# UNITED STATES PATENT AND TRADEMARK OFFICE

10/552,229

<b>Office Action Summary</b>	<b>Application No.</b> 10/552,229	<b>Applicant(s)</b> DINKELACKER, WOLFGANG	
	<b>Examiner</b> Sunil K. Singh	<b>Art Unit</b> 3732

### DETAILED ACTION

*FIG. 15*

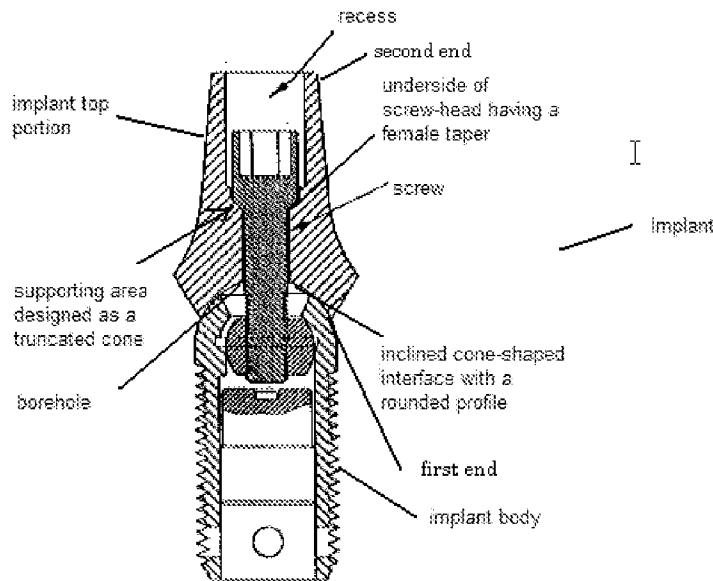
Lustig et al. discloses an implant having: an implant body having a longitudinal axis; an implant top portion having a through-borehole (825 and 915), a first end that mate with the implant body at an interface (See Fig. Below) and at a second opposing end, a cylindrical recess (See Fig. Below) arranged coaxially with the through-borehole, the bottom of the cylindrical recess; a connecting screw (see Fig. Below) that passes through the through-borehole and engages a threaded borehole (see Fig. below); a borehole that surrounds a through-borehole (825 and 915) for connection screw and a recess (see Fig. Below) with a supporting area designed as a truncated cone (Shown in Figure below)(Fig. 1-17) for the screw head; a screw head having an underside that has a conical recess having a widest part facing toward the implant body when the connecting screw is in place (Fig. 44, 46); an implant top that is adapted to the profile of the implant body by means of a screw (Column 2, Lines 58-67). It is inherent that the female taper and the truncated cone are brought into close contact when the connection

screw is tightened. Lustig et al. further discloses an implant where the interface between the implant body and the implant top portion has a head that runs at a right angle to the longitudinal axis of the implant body (Figs. 15 and 43c); an interface between the implant body and the implant top that has a profile adapted to a comb shape of the jaw (Fig. 43c); a profile that is inclined toward the buccal side and the lingual side (Fig. 43c); and where the profile toward the buccal side and the lingual side is circularly rounded and also has a bell shape (Figs. 1-17, 43b and 43c). Lustig further discloses a jaw implant where the inclined faces of the buccal side and on the lingual side in the interface area of the implant body form an angle, which is larger than the angle between corresponding inclined surfaces on the buccal side and the lingual side in the interface area of the implant top portion; and where the rounded surface on the buccal side and the lingual side have a smaller radii of curvature in the interface area of the implant top portion than the corresponding rounded surfaces on the buccal side and on the lingual side in the interface area of the implant body (Figs. 15-17, 43b and 43c). However, Lustig fails to disclose an implant system wherein the bottom of the cylindrical recess being formed of as a raised truncated cone.
